RECEIPT DATE: 1/9/17 **ONSITE SEWAGE DISPOSAL SYSTEM** P 560502
 APPROVAL DATE: 2/2/17 ^{SEC} **PERMIT: CONSTRUCTION** A _____
 PROPERTY ADDRESS: 2034 Millers Mill Road
 SUBDIVISION: Millers Mill Development LOT: PAR 22 TAX ID: 04-320018
 CONTRACTOR: Fogle's Septic Clean Inc. EMAIL: zack@foglesinc.com
 CONTRACTOR ADDRESS: 580 Obrecht Road, Sykesville, MD 21784 PHONE: 410-795-5670

RE: BAT Plan
Millers Mill Development
Tax Map: 14, Parcel 22

The following comments apply to the plan prepared by NJR & Associates Land Surveying and Planning Inc. Applicant is advised to revise and resubmit.

SITE PLAN FOR BAT INSTALLATION SHEET 1 OF 1

RED LINE REVISIONS BY NJR & Assoc. 12/22/2016

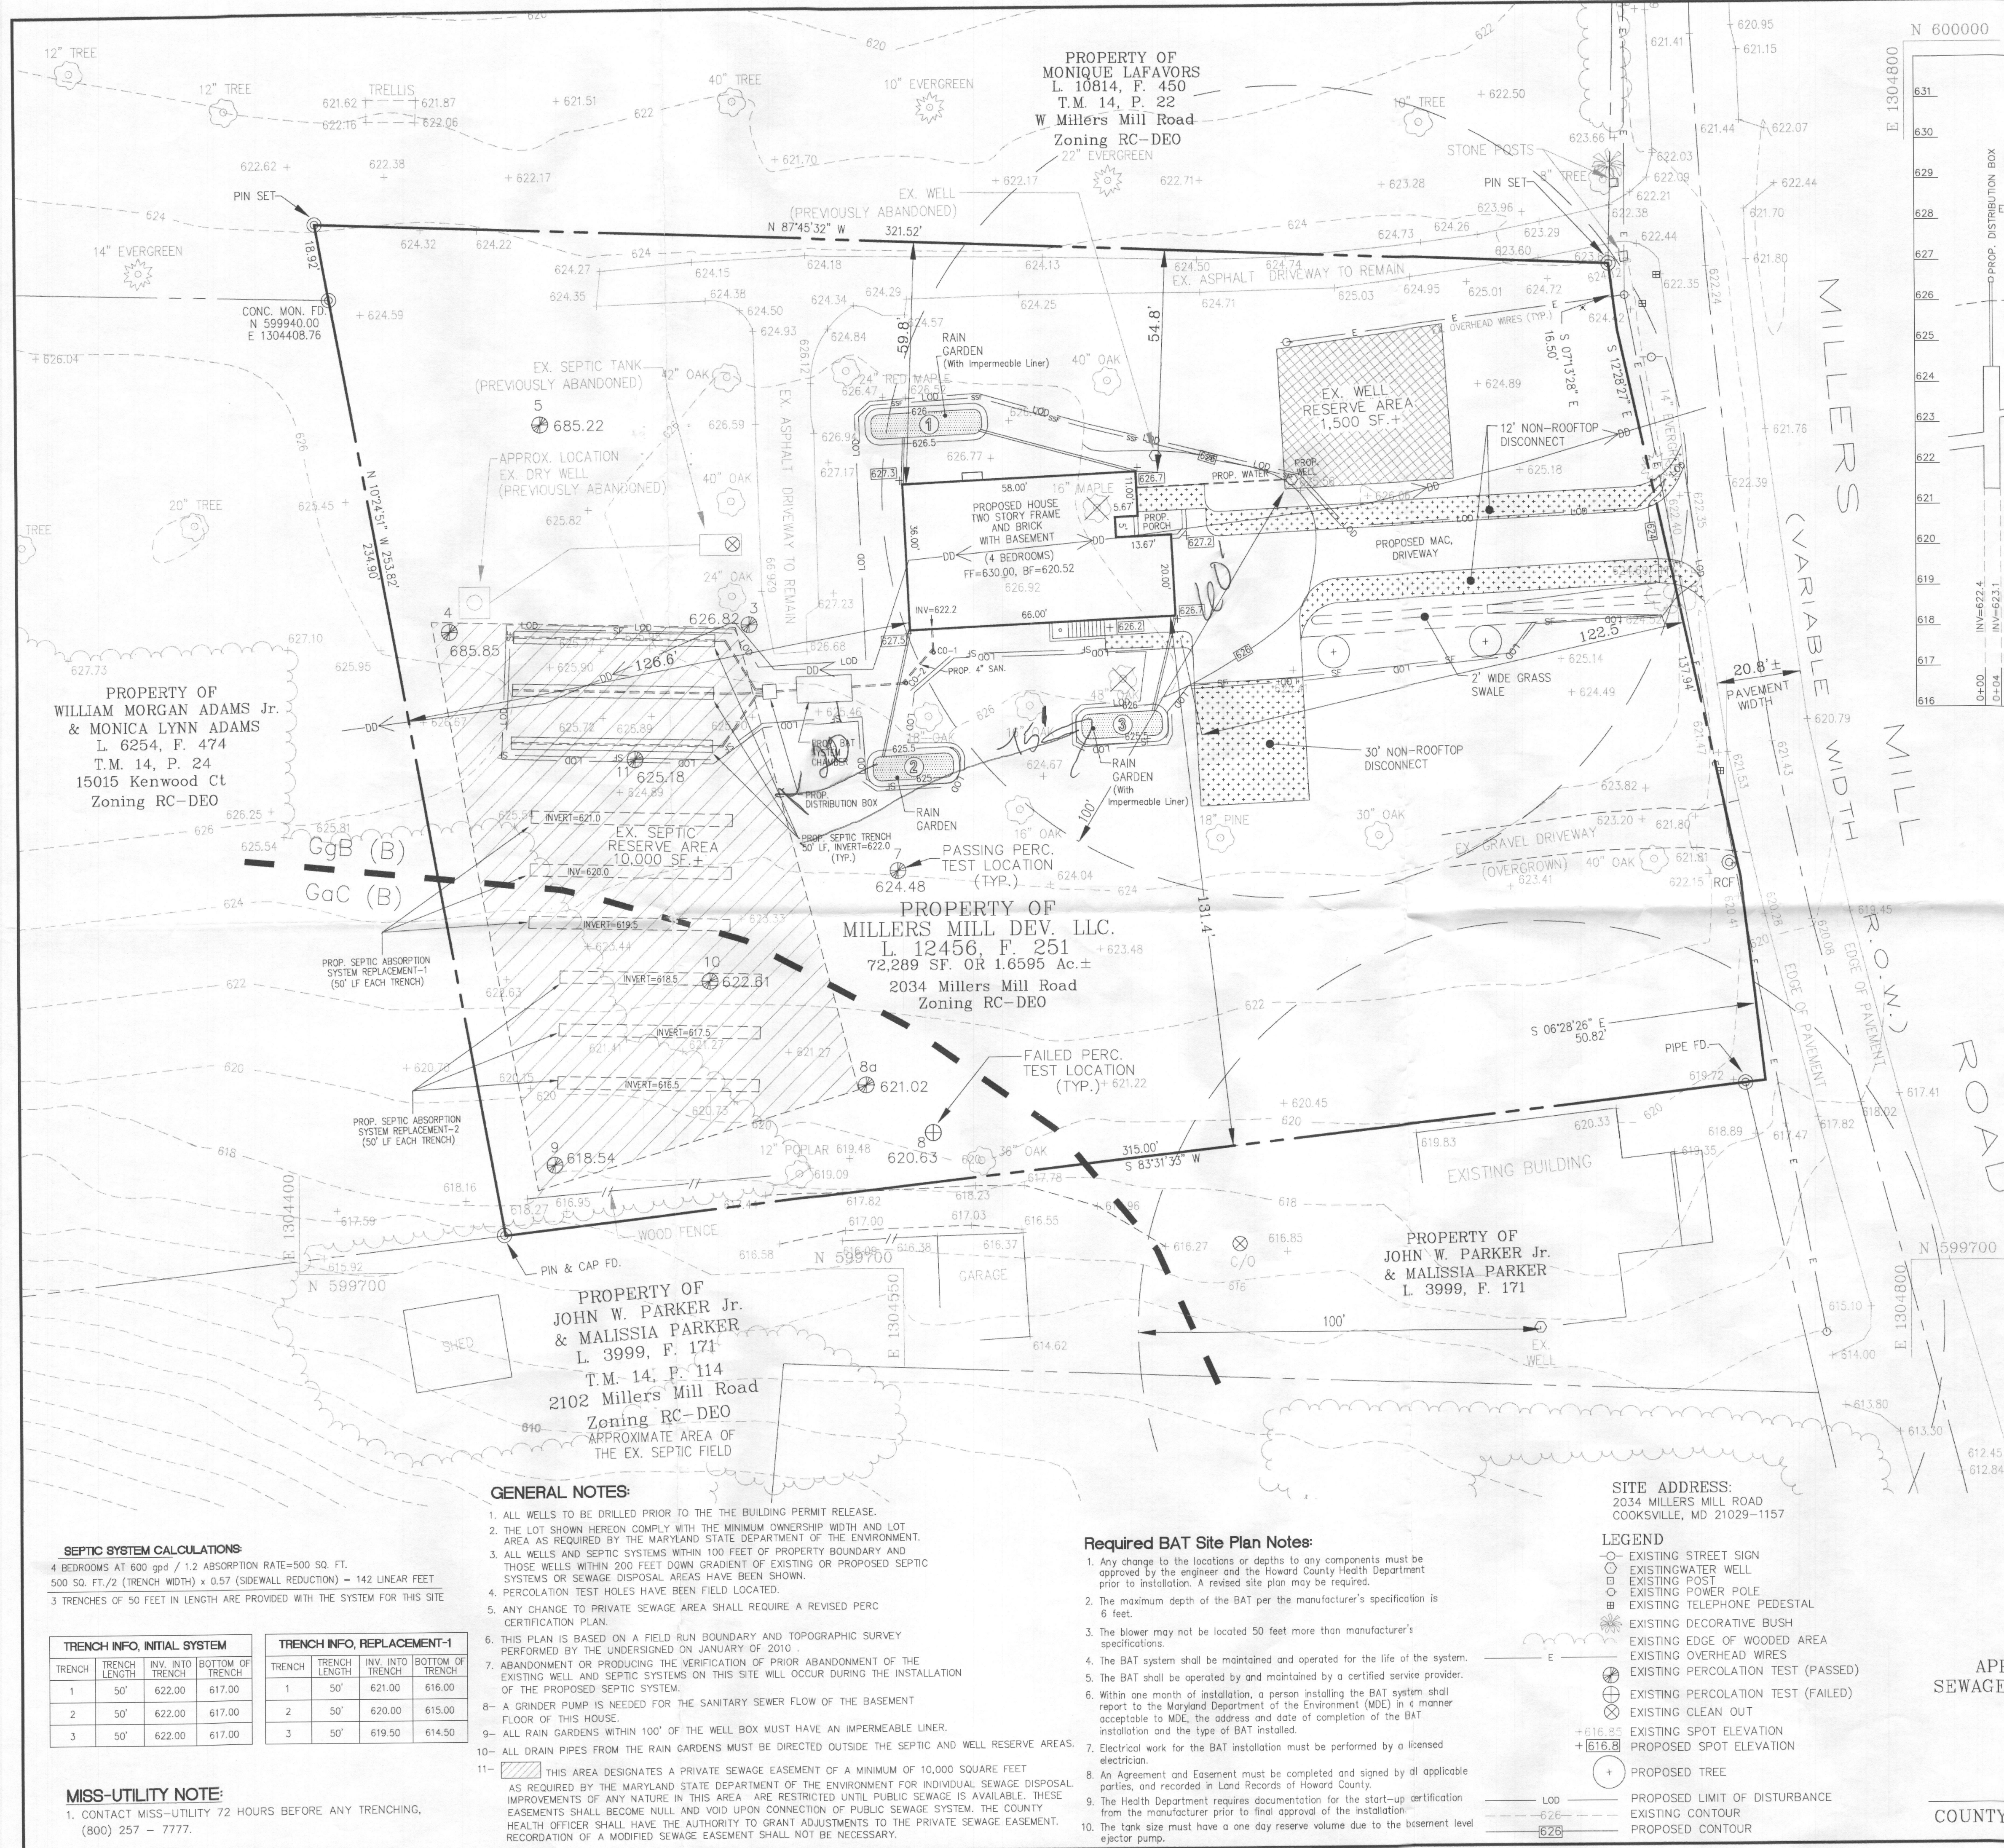
At this point, we can put this email in the file as proof of your intentions and redline it ourselves to be a 1500g tank. I believe the engineer did the original redline. Thanks
Jeff

Greg: we got a call from a contractor asking about the specs for the Millers Mill septic system. In doing that, we noticed that the engineer changed the BAT to a 3000 gallon septic tank. This would be a very large and custom built tank. A 1500 gallon tank would meet our size requirements for a 5 bedroom house. I wanted to double check whether you wanted such a greatly oversized tank. Thanks
Jeff
